PROJECT NAME: MIDWAY TERRACE APARTMENTS 9007-0101-18

PROJECT NUMBER: 2023050074

APPLICATION: MAJOR SITE PLAN #30183

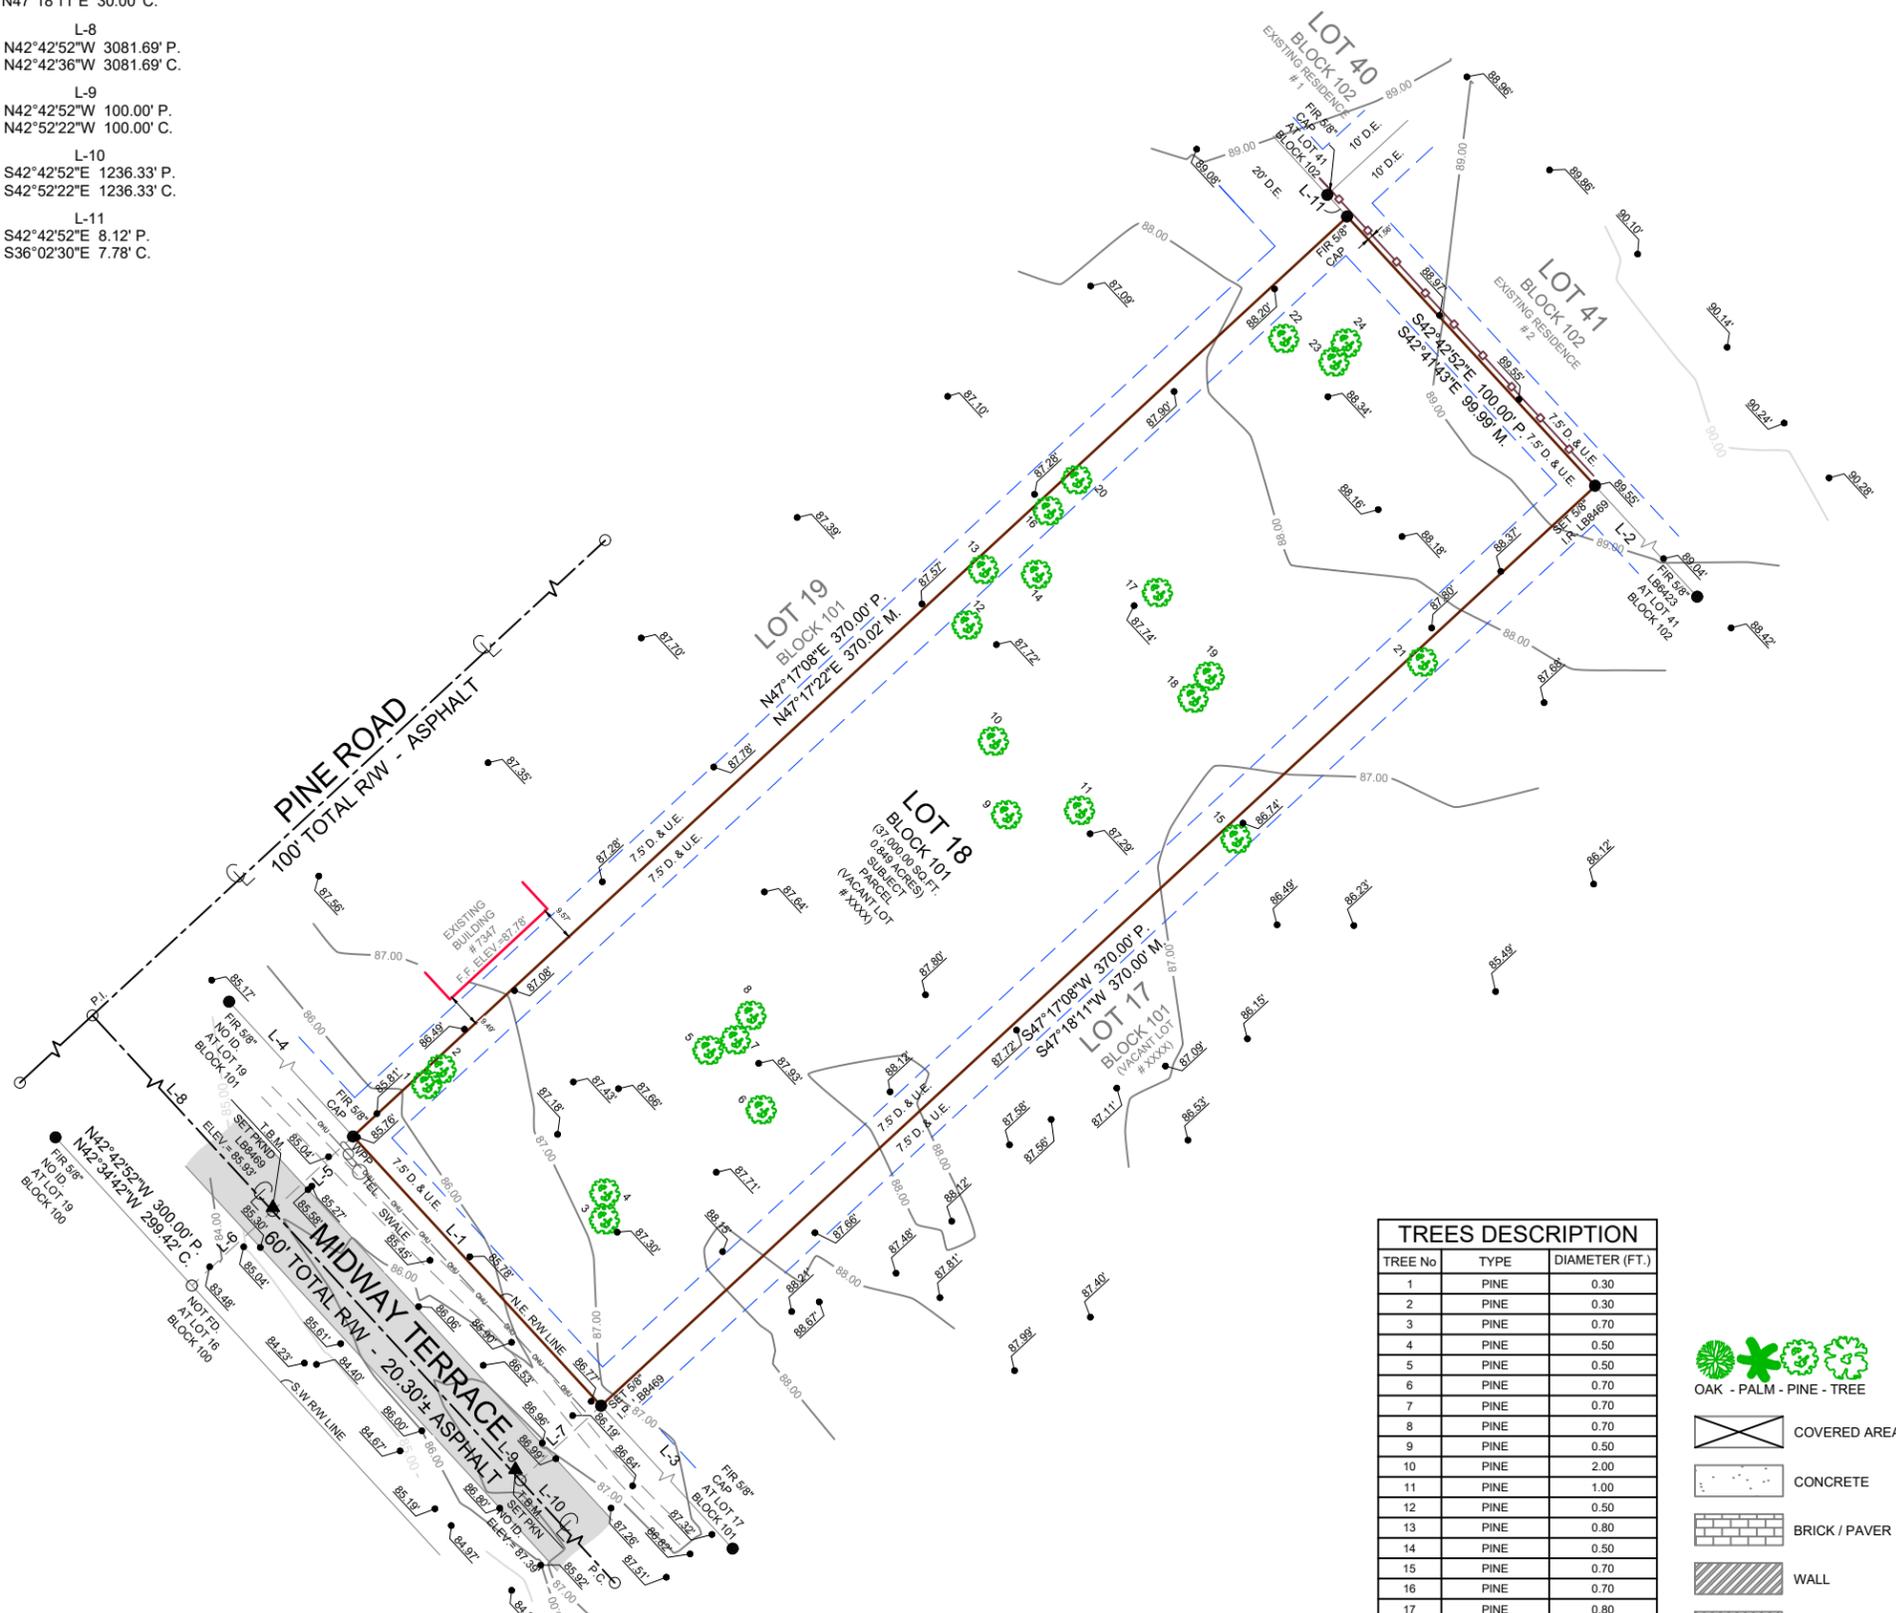
- 31 DEPARTMENT: LSCAPE - LANDSCAPE DESIGN AND IRRIGATION
REVIEW ITEM: 2.12.18 - All trees 10" DBH and larger
STATUS OF REVIEW: NO
REMARKS: Aerial shows many trees on the parcel not shown to be removed, please clarify
